PARK PLACE ON PEACHTREE

This project scope consists of a new porte cochere to replace the original 1980s era construction, with the intent to utilize the existing below-grade structure as its support and maintain the same approximate footprint. The original slanted glass storefront will be removed and replaced with a new storefront system to match the recently renovated sliding glass entry. The sliding glass entry will be maintained to save costs. The new porte cochere construction consists of a steel moment frame with suspended metal composite

PORTE COCHERE CONSTRUCTION DOCUMENTS

Subject: Revision Narrative – Addendum #1

SHEET TITLE: ENVELOPE DETAILS

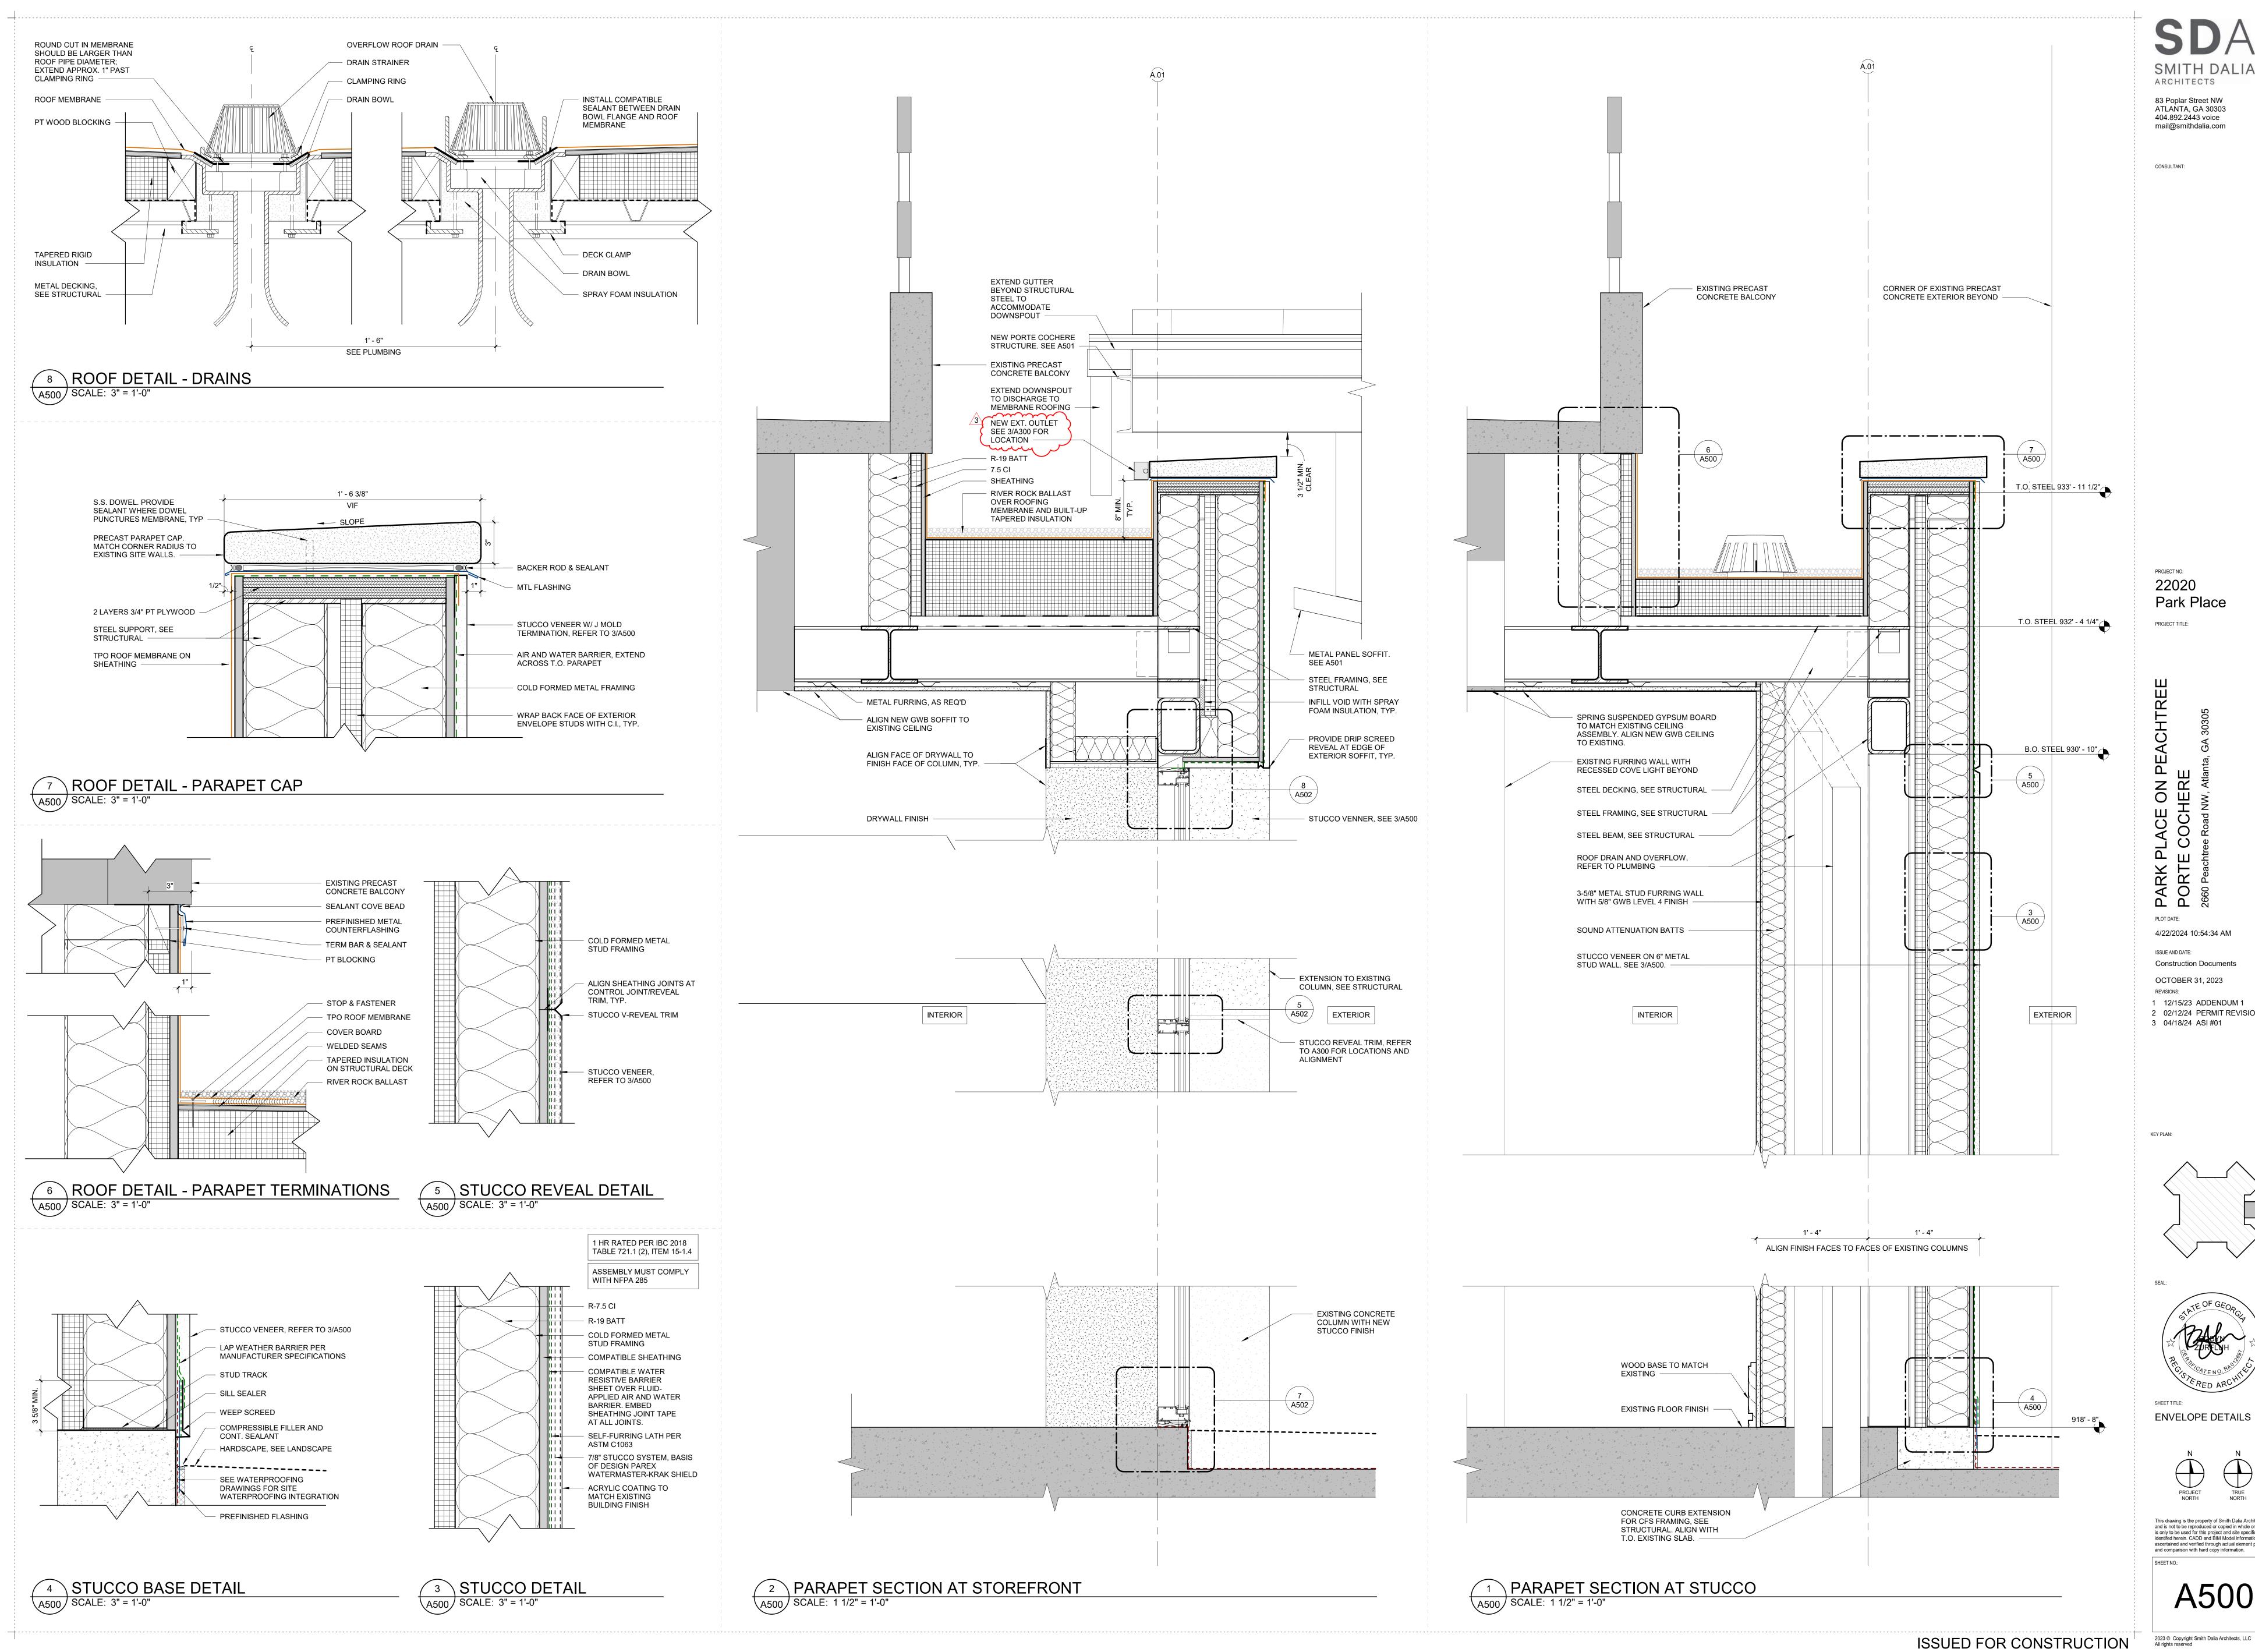
E202 – Addition of owner requested interior light fixtures at lobby ceiling and	-	ceiling. Clarification of L-9 canopy li	ght fixture mounting at A	CM.		
	, , ,	-	ceiling. Clarification of L-9 canopy li A300 – Addition of owner reques A500 - Addition of new owner re	ght fixture mounting at A sted exterior power out	CM. lets for holiday wreath.		
·	exterior power outlets for holiday wreath.	•	ceiling. Clarification of L-9 canopy li A300 – Addition of owner reques A500 - Addition of new owner re wreath.	ght fixture mounting at A sted exterior power out	CM. lets for holiday wreath.

A500 - Steel decking graphic revised per structural coordination comments.

- Note to provide AESS at all permanently exposed structural steel added per structural coordination comments and RFP RFI responses.

GLAZING DETAILS

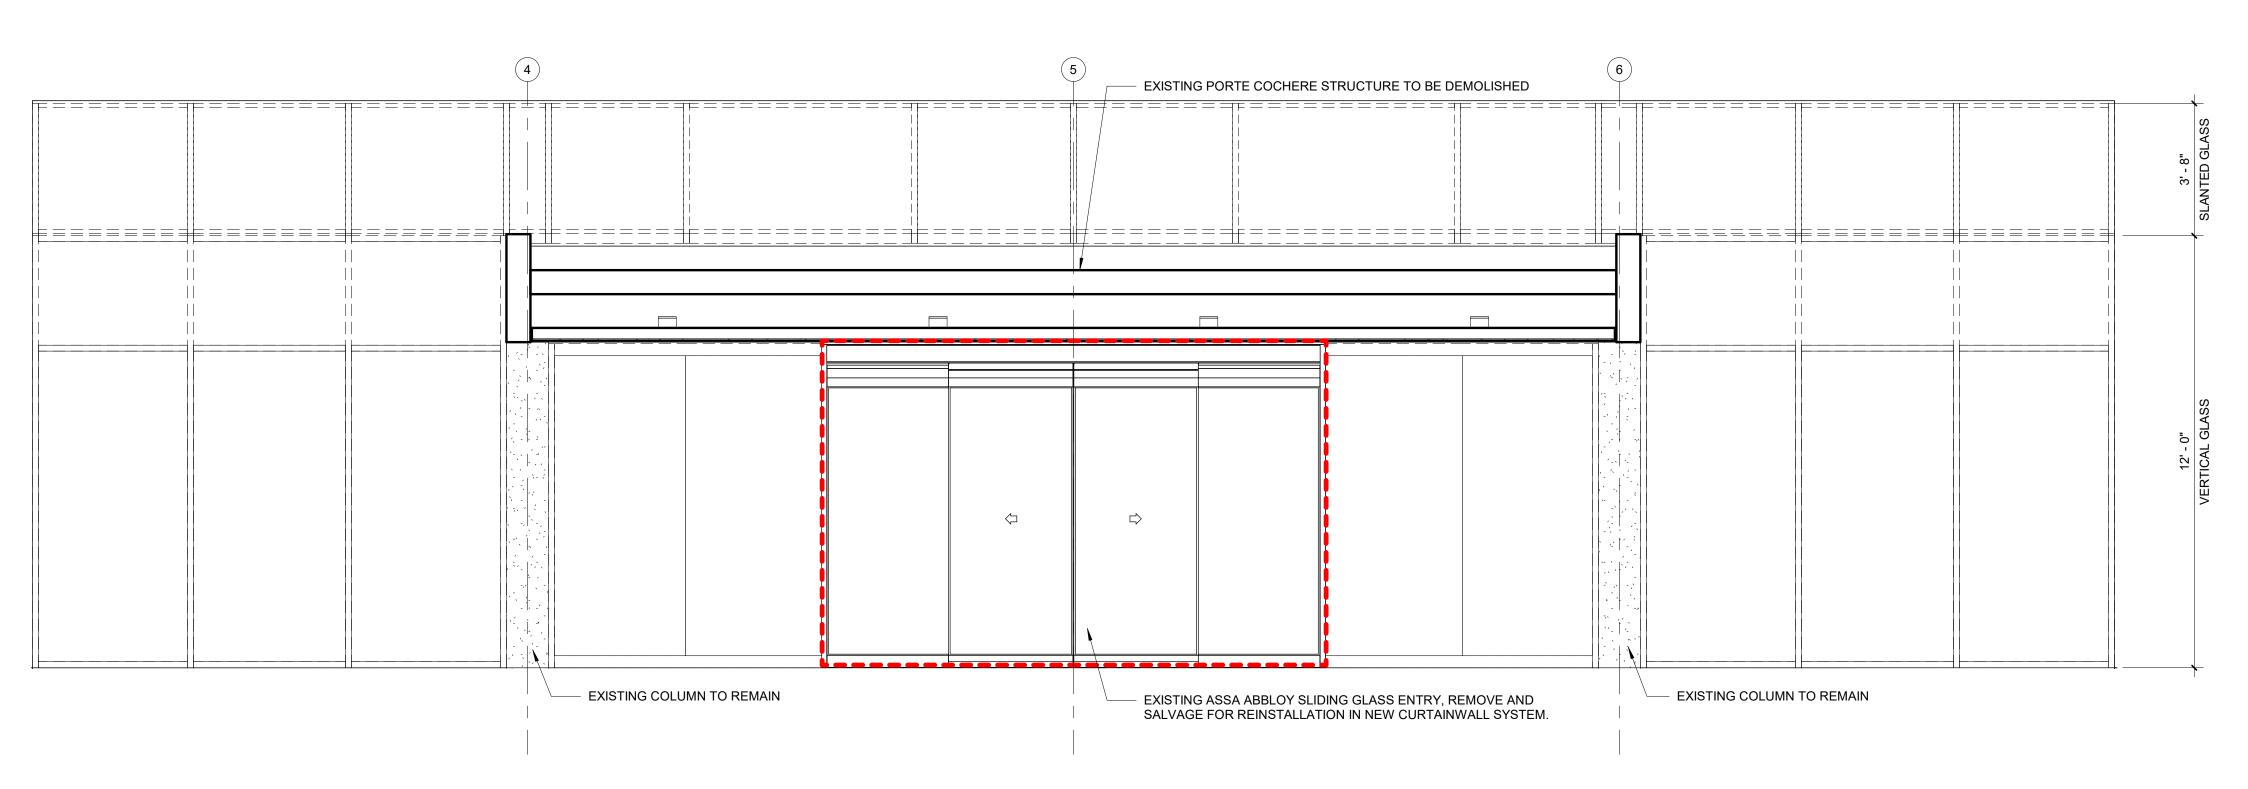
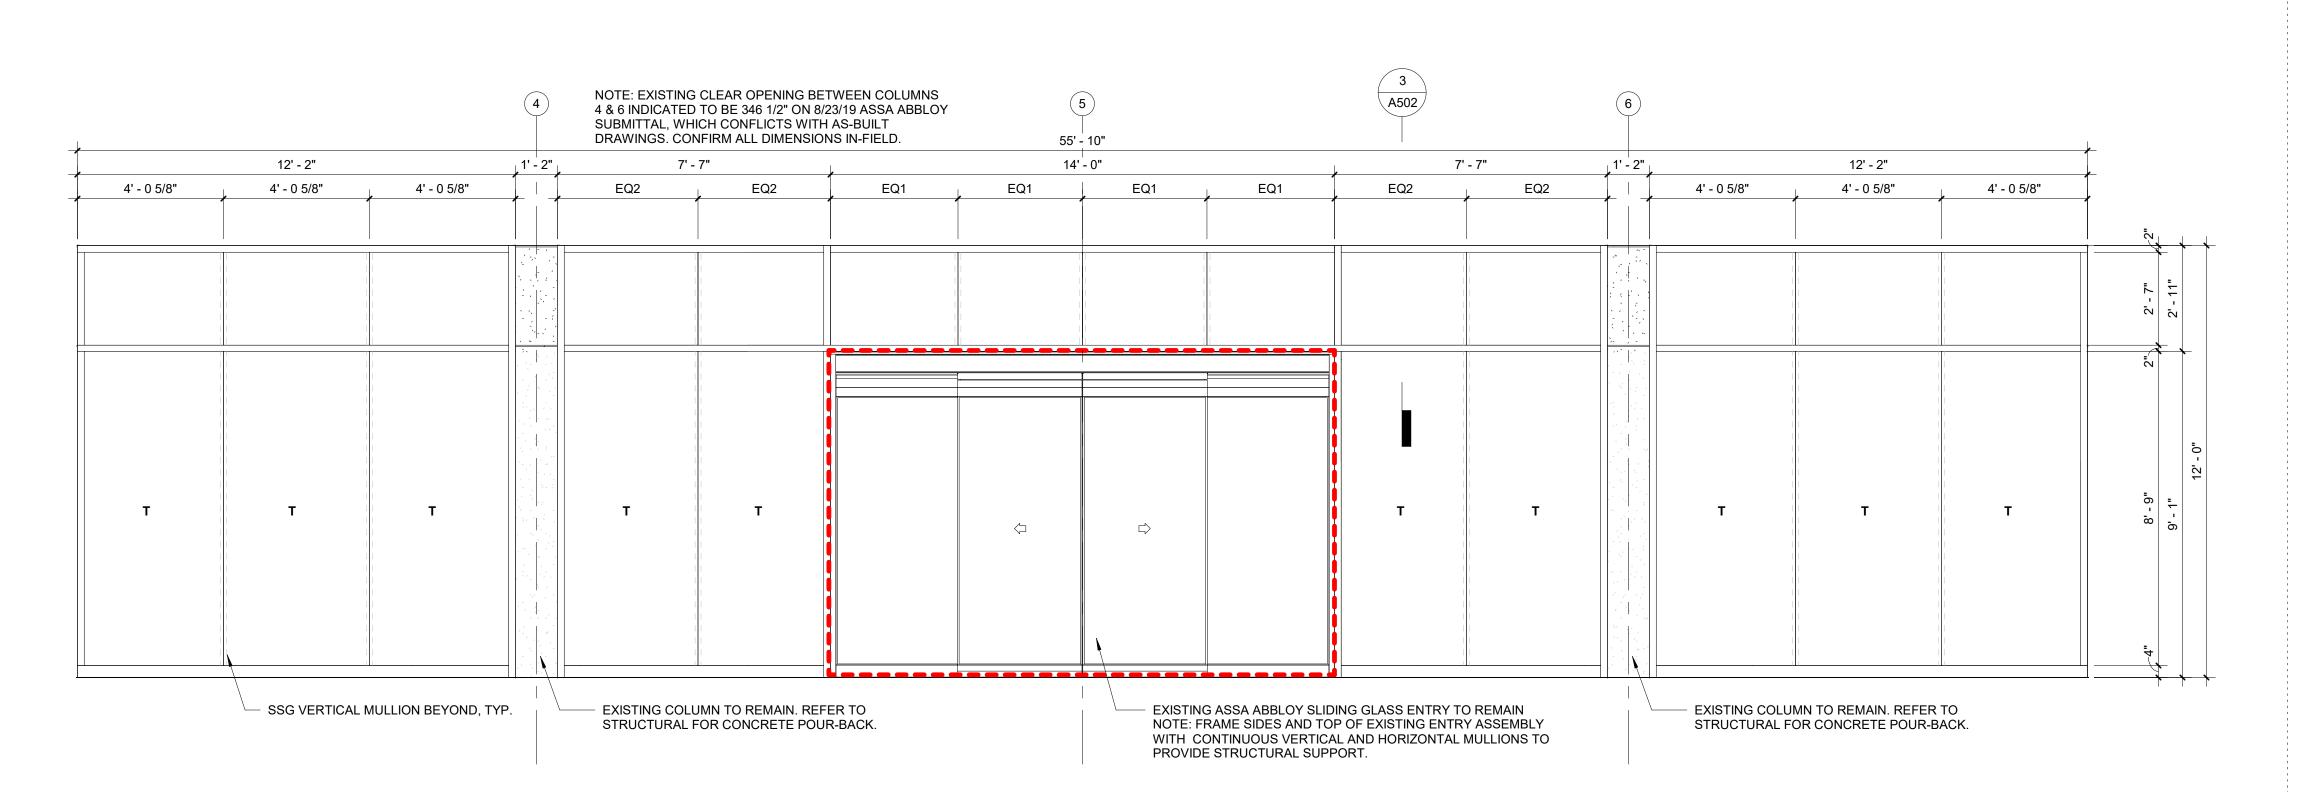
- Updated note for columns 4/A.01 & 6/A.01 per structural coordination comments.
